SERVICE BULLETIN

DATE: 9-Dec-05 BULLETIN NUMBER: 247 Update (pg. 1)

SUBJECT: Fuel Filter Bracket # 300103

MODEL AFFECTED: Universal M 25XPB, M 25XPBC, M 35B, M 35BC, M 40B

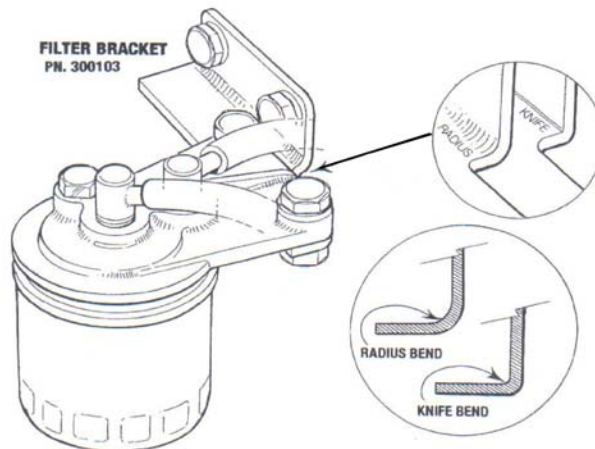
DETAIL: FRACTURES HAVE BEEN REPORTED FROM THE FIELD IN THE AREA OF THE 90-DEGREE BEND

IN THE #300103 BRACKET. INSPECTION OF BRACKETS RETURNED FROM THE FIELD HAS SHOWN THAT THE 90- DEGREE BEND WAS INCORRECTLY PERFORMED USING A KNIFE-EDGE BENDER RATHER THAN A RADIUS BENDER.

THIS KNIFE EDGE BENDING PROCESS PLACES A NOTICEABLE CREASE ALONG THE BEND WHICH CAN STRESS THIS AREA OF THE METAL CREATING THE POSSIBILITY OF A FRACTURE TAKING PLACE ALONG THIS CREASE.

NOTE: TO LOW OF AN ENGINE IDLE SPEED WILL PRODUCE FILTER VIBRATIONS THAT CAN AFFECT THE FILTER BRACKET AND LED TO ITS FRACTURING AT THE 90 DEGREE BEND.

THE ILLUSTRATION BELOW SHOULD HELP TO SHOW THE DIFFERENCES IN THE 90 DEGREE BEND.

THE ABOVE SUBJECT MODELS USING THIS BRACKET MANUFACTURED PRIOR TO SEPTEMBER 2004 (E409) ARE SUSPECT. VISUALLY INSPECT THE BRACKET AND IF A CREASE IS VISIBLE ALONG THE BEND AREA. CONTACT WESTERBEKE CORPORATION AT 508-823-7677. PROVIDE THE ENGINE MODEL AND SERIAL NUMBER AND A SHIPPING ADDRESS AND A REPLACEMENT BRACKET WILL BE SENT AT NO CHARGE.
